To: All U.S. and Canadian Volvo Retailers
Subject: XC90 Courtesy Upgrade C10006

**XC90 Courtesy Upgrade C10006
Model Year 2016 XC90**

XC90 Courtesy Upgrade (C-10006)

REF NO:
TJ 30991

Digital Owner's Manual before & after Courtesy Upgrade

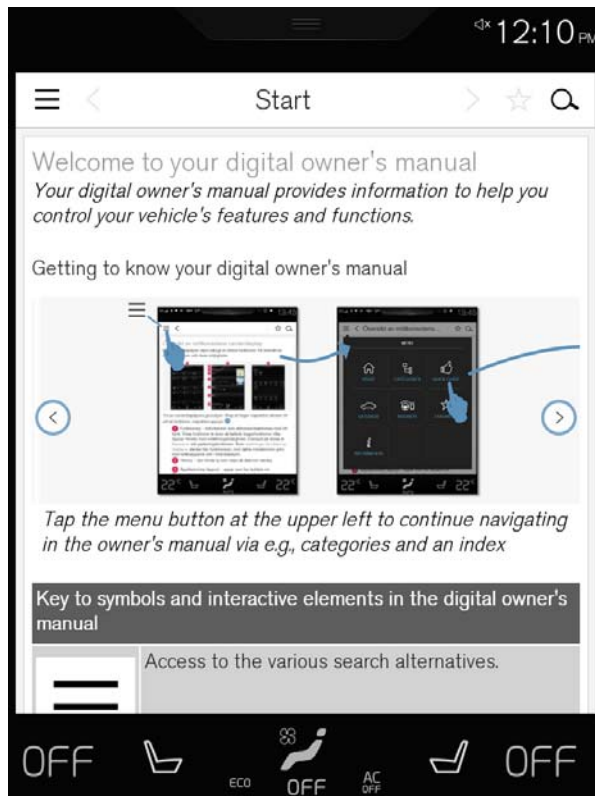
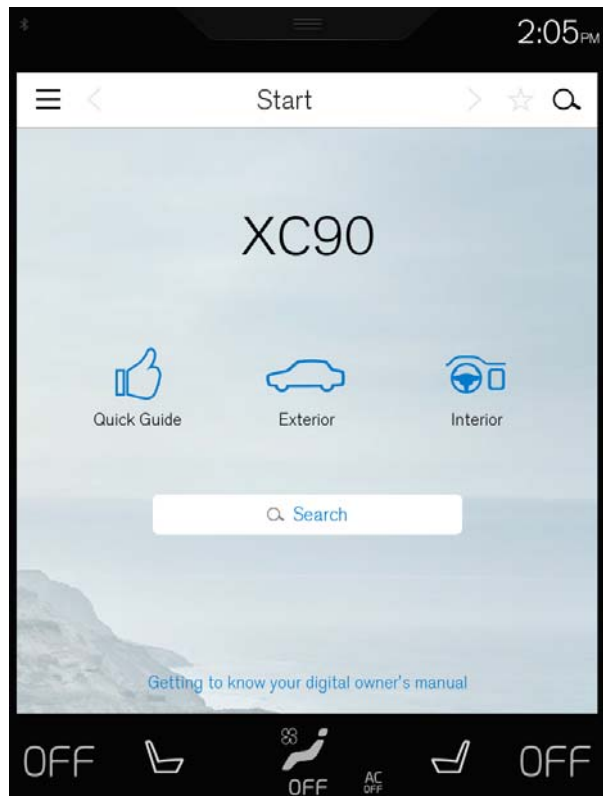
One easy way to check if this update has been performed is by accessing the Digital Owner's manual.
